Access Compliance Report

Public Rights-of-Way

(Pedestrian Signals)

Intersection ID: N/A	Main Street:	Cross Street: N/A	Location: N/A
ADA ID: 49BC9CBB583E	Signal Type: One Push Button-APS	Overall Compliance: No	Severity Score: BTN 1: N/A BTN 2: N/A No BTN: N/A
Codes/Mitigation Info/Possible Solution		Field Measurements/Component Compliance

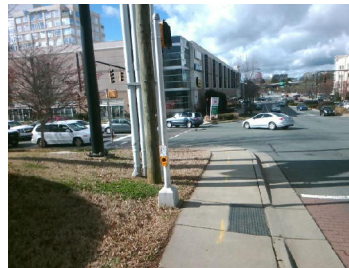
PROW/ADA: TMUTCD 4e.08, R404.2, R404.3, R404.7.3, R209.1, MUTCD 4e.10

Yes	B 1 Clear Xing Direction?	ClearlyMarked	N/A	B 2 Clear Xing Direction?	N/A
	B 1 Crossing Direction	To N		B 2 Crossing Direction	N/A
Yes	B 1 DistanceTo XWalk (in)	0.0	N/A	B 2 DistanceTo XWalk (in)	N/A
No	B 1 DistanceTo Curb (in)	80.0	N/A	B 2 DistanceTo Curb (in)	N/A
Yes	B 1 Diameter (in)	2.0	N/A	B 2 Diameter (in)	N/A

Possible Solutions: Replace Signal Push Button With APS Button on New Post. Remove & Relocate Sign.
